# Access Compliance Report

## Public Rights-of-Way

### (Pedestrian Signals)

Intersection ID: N/A	Main Street:	Cross Street: N/A	Location: N/A
ADA ID: 1144318F2735	Signal Type: One Push Button-APS	Overall Compliance: No	Severity Score: BTN 1: N/A BTN 2: N/A No BTN: N/A
Codes/Mitigation Info/Possible Solution		Field Measurements/Component Compliance

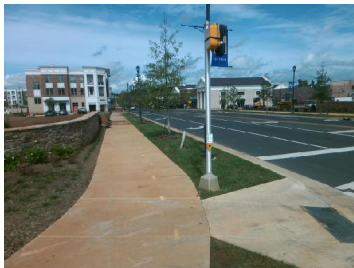
Surveyor Notes: OUT OF SERVICE

PROW/ADA: TMUTCD 4e.08, R404.2, R404.3, R406.2, R209.1, TMUTCD 4e.10, MUTCD 4e.08, R104.2,

Possible Solutions: Replace Signal Push Button With APS Button on New Post. Remove & Relocate Sign.
